1 REDLINE REVISION 6/6/08

MD 97 (GEORGIA AVE) AND MD 586 (VEIRS MILL RD) / PRICHARD ROAD

TRAFFIC SIGNAL PLAN

TS NO. 213 A | DRAWING NO. 1 OF 3 | SHEET NO. 25 OF 42

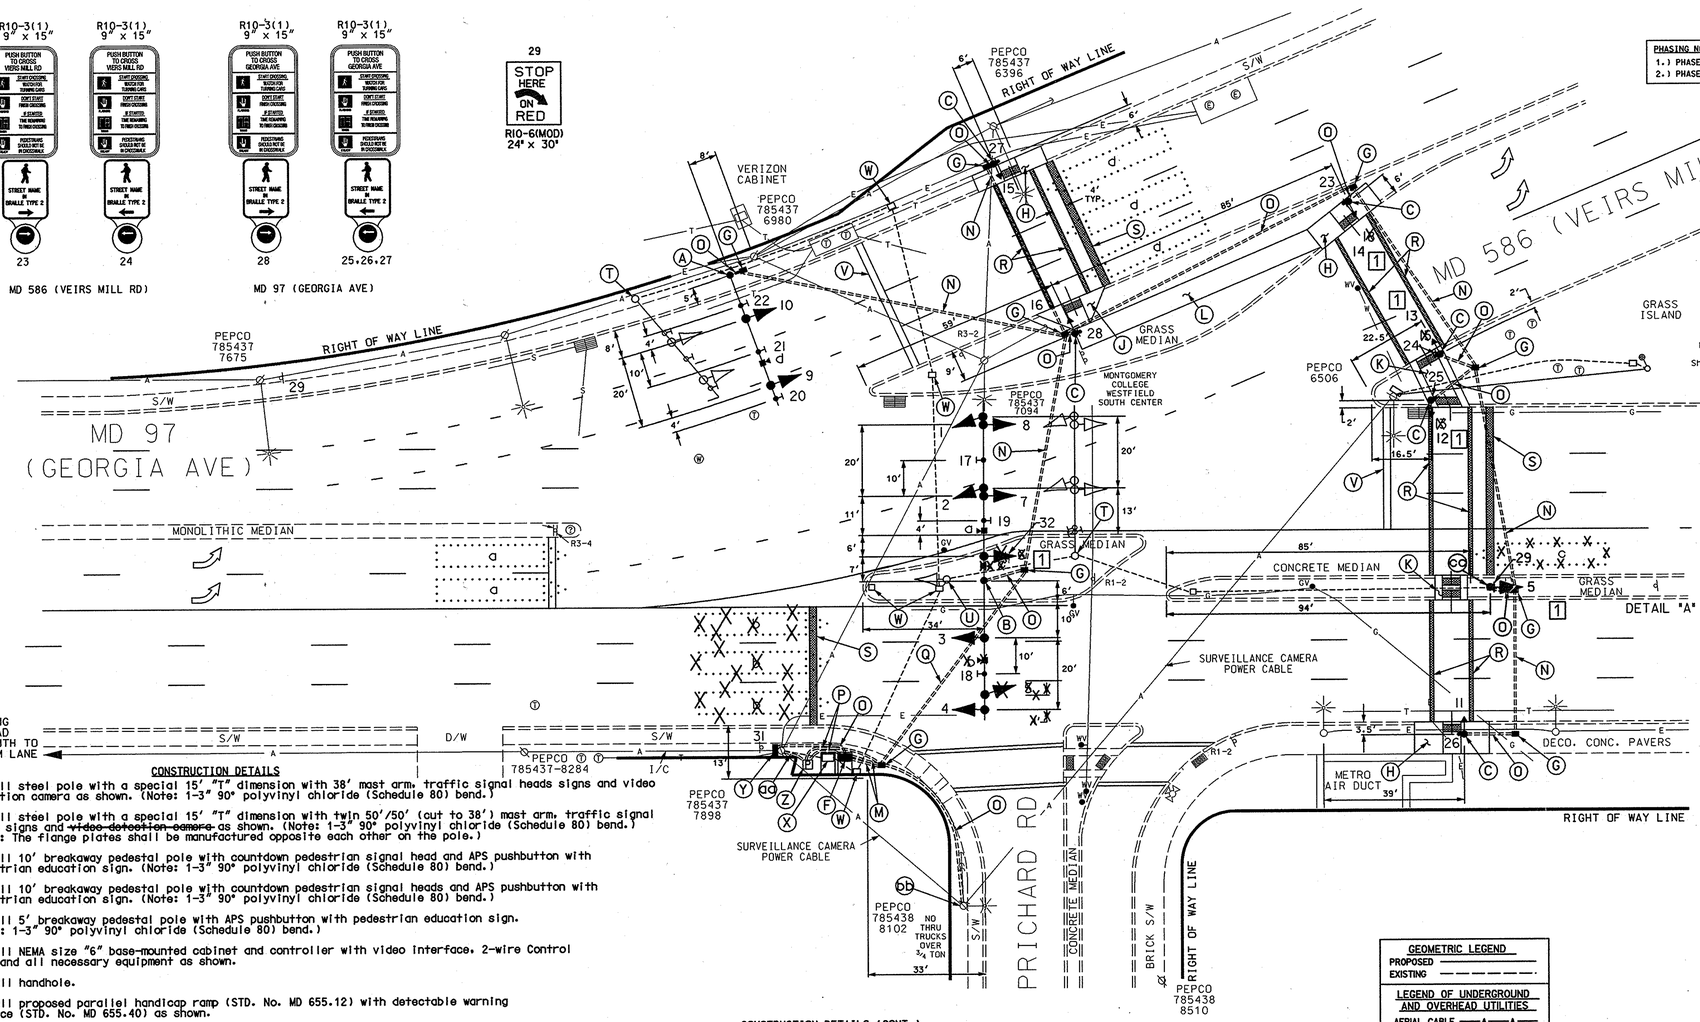
1 B. Install steel pole with a special 15' "T" dimension with twin 50'/50' (cut to 38') mast arm, traffic signal heads signs and ~~video detection camera~~ as shown. (Note: 1-3" 90° polyvinyl chloride (Schedule 80) bend.) (Note: The flange plates shall be manufactured opposite each other on the pole.)

1 cc. Remove existing handhole and install 20' breakaway pedestal pole with signal head and sign as shown.
